# PERMIT

SEWAGE DISPOSAL SYSTEM

ADDRESS 7328 Wye Avenue, Jessup, Maryland

OTHER REPAIR - Install sealed tank with an alarm device on it. Minimum volume for a sealed tank is 1500 gallons. This sealed tank must be watertight; must be parged inside and outside.

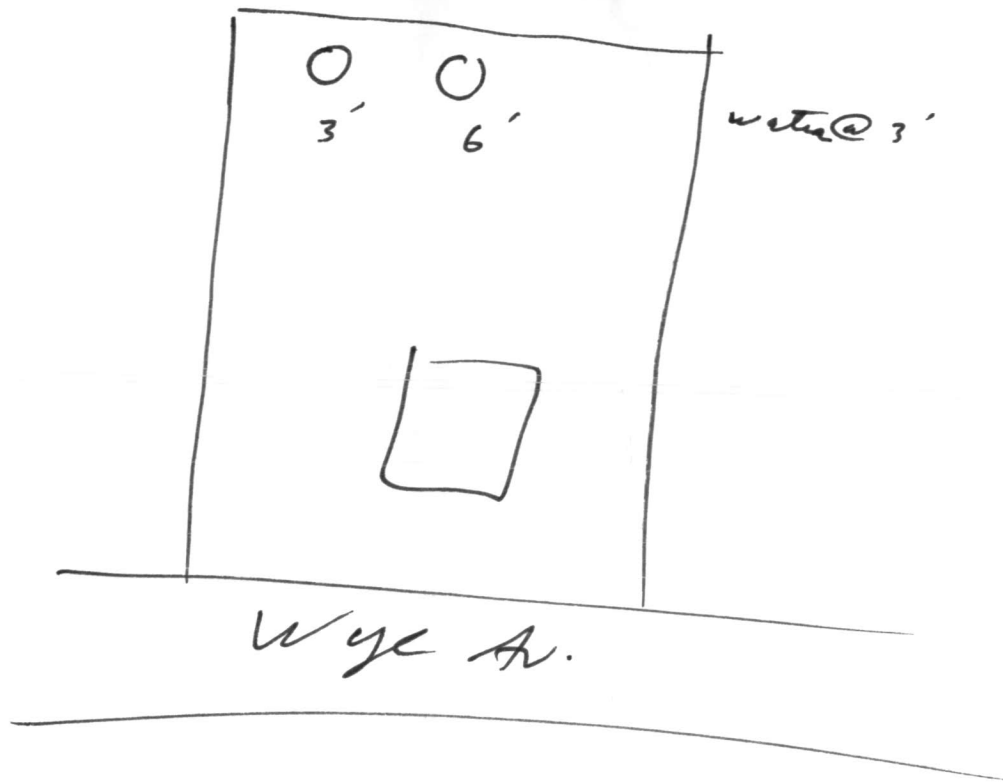
4/28/77 No answer at home phone #1  
12:05 P.M.

4/28/77 Dye tested bathroom fixture  
~ 3:30 p.m. No dye seen at ditch  
near road. Recall 4/29/77 F.S.  
4/29/77 Dye shows up in ditch  
near road & across road  
5/13 install sealed  
tank R.M.

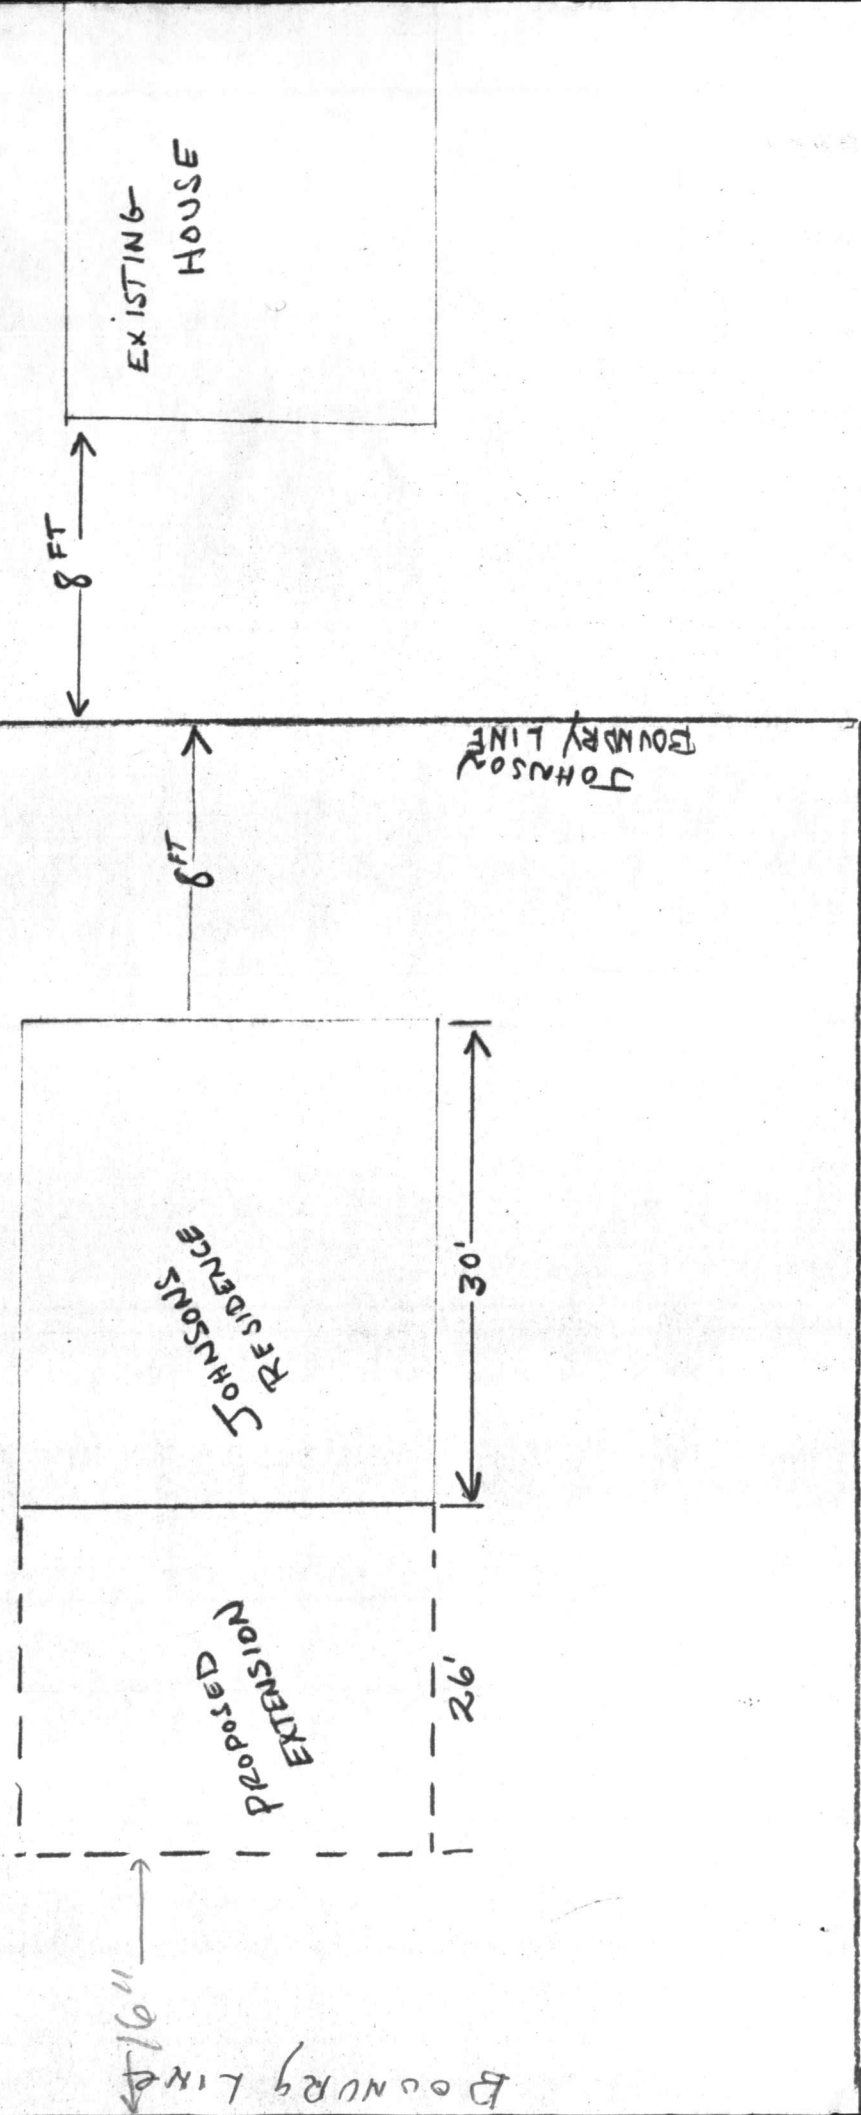
I visited this lot & dye tested their septic system. System is overflowing. When I spoke to the owner Charles Johnson he said the lot was 80' x 150' if so would an addition this large 26 x 26 be possible within current Building Restriction lines?

80' x 146'
